The purpose of this letter is to respond and demonstrate compliance with the conditions for the approval of the following cases: 01128 01076, a Site Development Plan for Subdivision; and 01128 01077, a Site Development Plan for Building Permit. These approvals were granted at the EPC hearing on January 17, 2002.

**SITE DEVELOPMENT PLAN**

PROJECT TITLE RAINBOW BOULEVARD NW ALBUQUERQUE, NM	JOB NO. 0105	DRAWN BY SD
PROJECT MANAGER GEORGE RAINHART AA	SHEET TITLE TRACT 18 VENTANA RANCH SITE PLAN FOR SUBDIVISION

**DRAWN BY:** SD  
**JOB NO.:** 0105  
**PROJECT MANAGER:** GEORGE RAINHART, AIA  
**SHEET TITLE:** TRACT 18 VENTANA RANCH  
SITE PLAN FOR BUILDING PERMIT

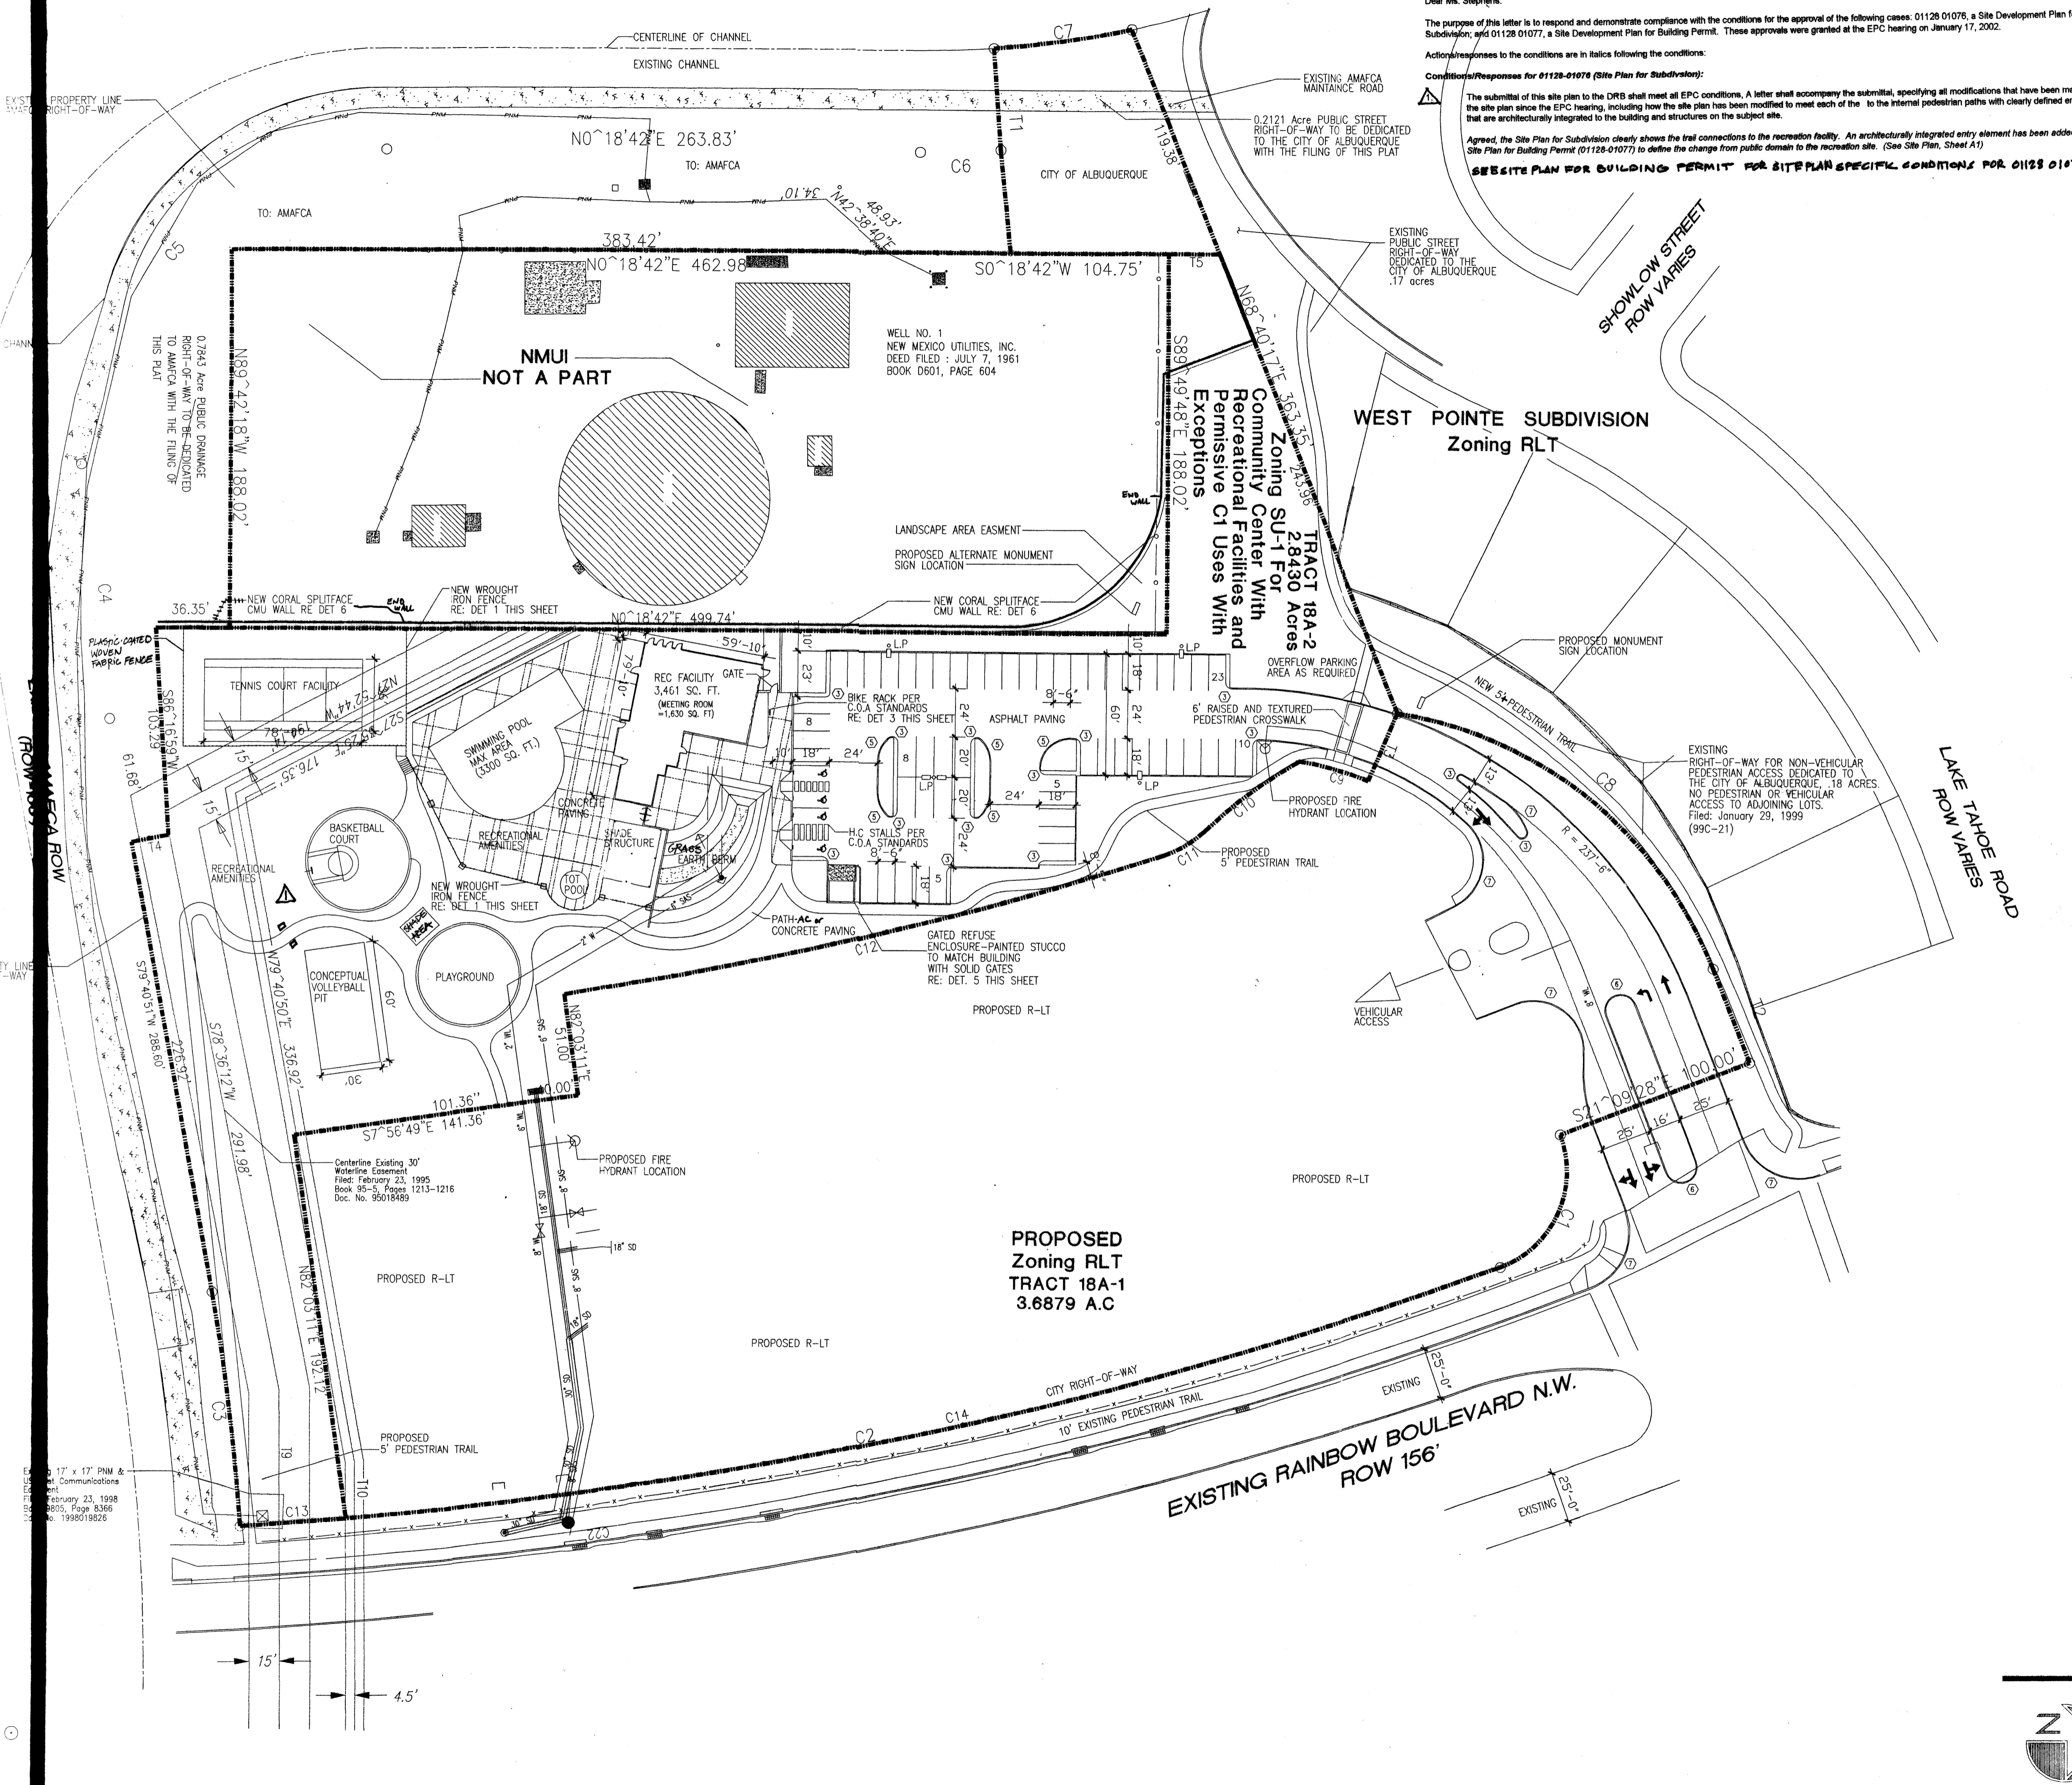
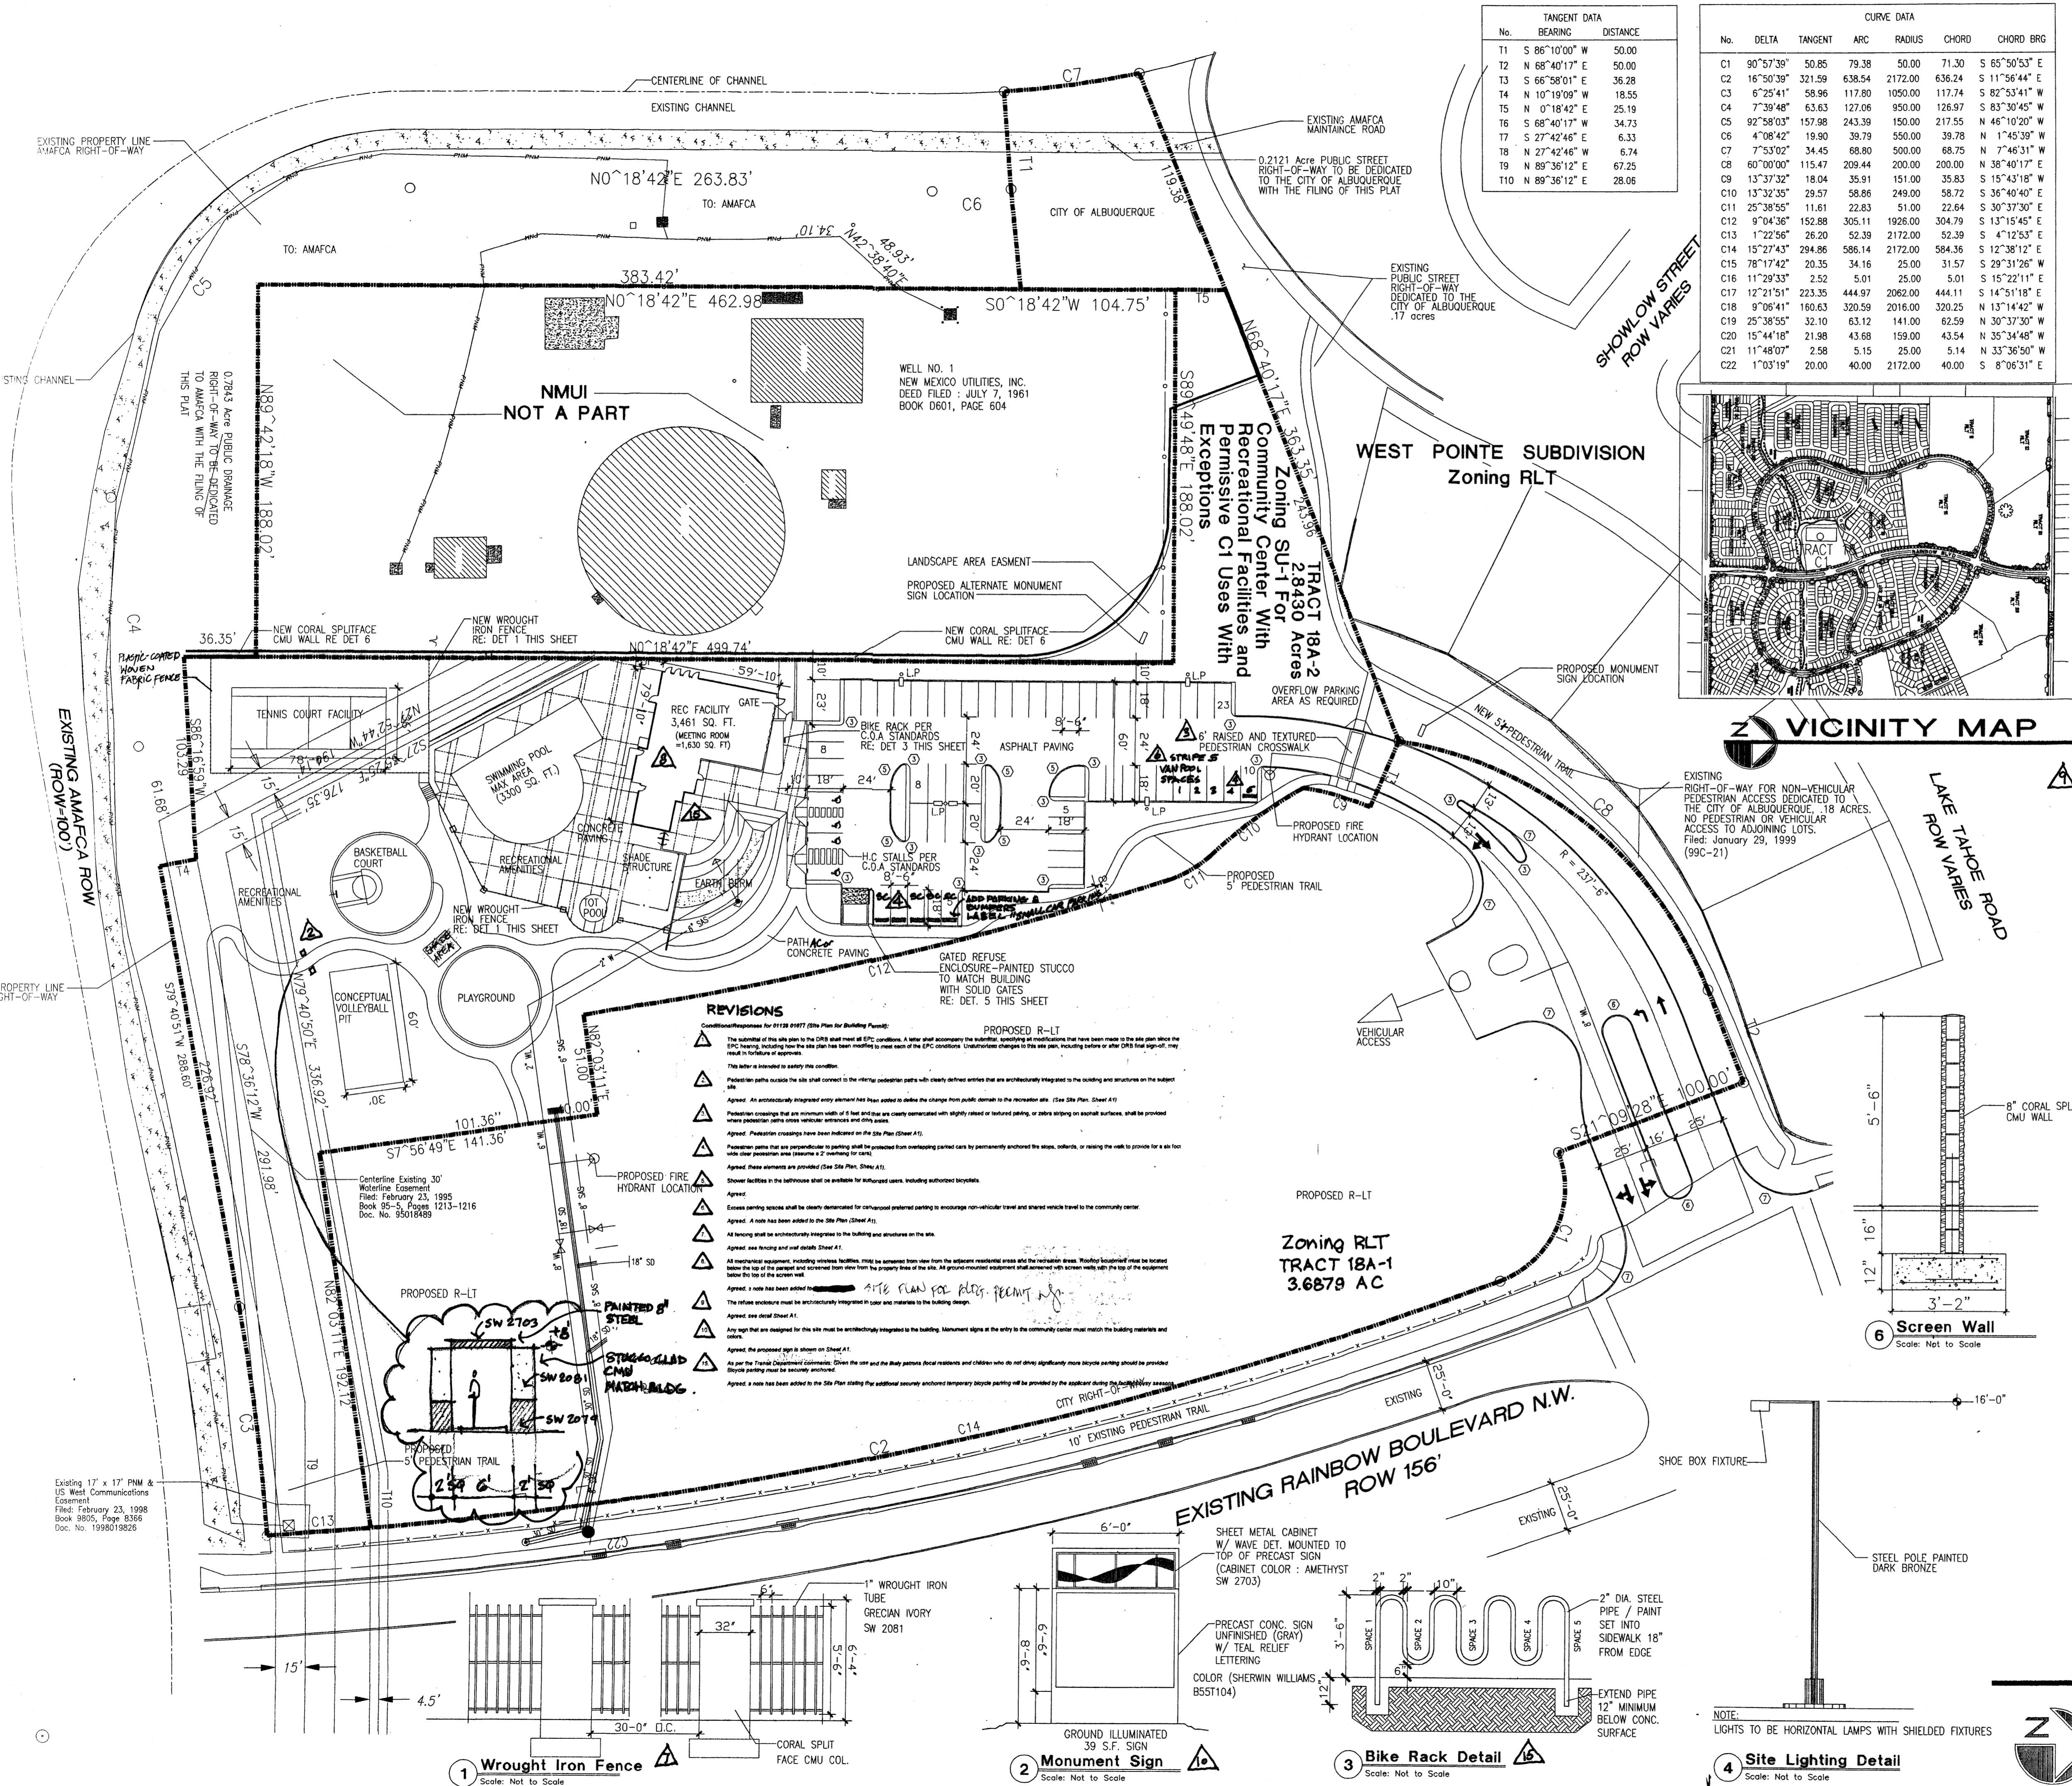
The submittal of this site plan to the DRB shall meet all EPC conditions. A letter shall accompany the submittal, specifying all modifications that have been made to the site plan since the EPC hearing, including how the site plan has been modified to meet each of the to the internal pedestrian paths with clearly defined entries that are architecturally integrated to the building and structures on the subject site.

Agreed, the Site Plan for Subdivision clearly shows the trail connections to the recreation facility. An architecturally integrated entry element has been added to the Site Plan for Building Permit (01128-01077) to define the change from public domain to the recreation site. (See Site Plan, Sheet A1)
